Building Two Advanced Manufacturing Research Facility (SSD-58591961- Mod-1)

Subject: Response to Request for Additional Information No.2

Figure 1: Southern elevation (Approved)
Source: Architectus

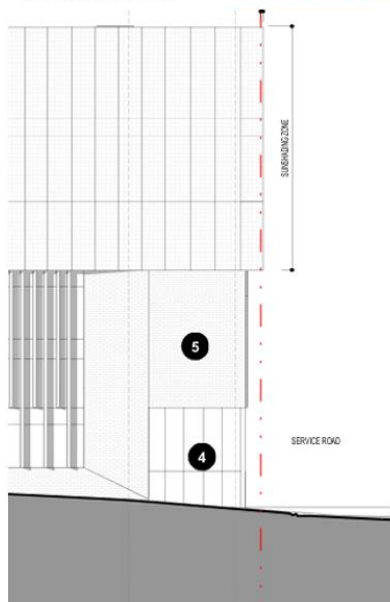
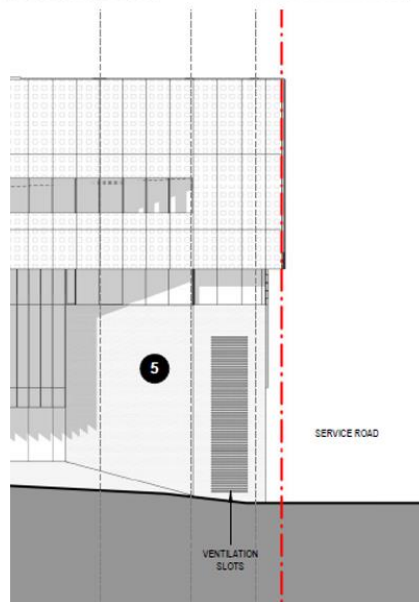
LCC raises concerns that glazing has been replaced with grills on the south-eastern façade and that the visual prominence of the timber structural system has been compromised. LCC request updated 3D visualisations to help interpret the changes to this façade.

The south-eastern corner of the southern façade is approved as masonry and metal mesh, as shown in **Figure 1** below. The proposed modification proposed masonry with ventilation slots in this location, as shown in **Figure 2**. This area was never proposed to be glazed.

The visibility of structural timber through a glazed façade remains a prominent design feature of the development, especially on the northern and eastern façades adjacent to AMRF Park and the Service Road.
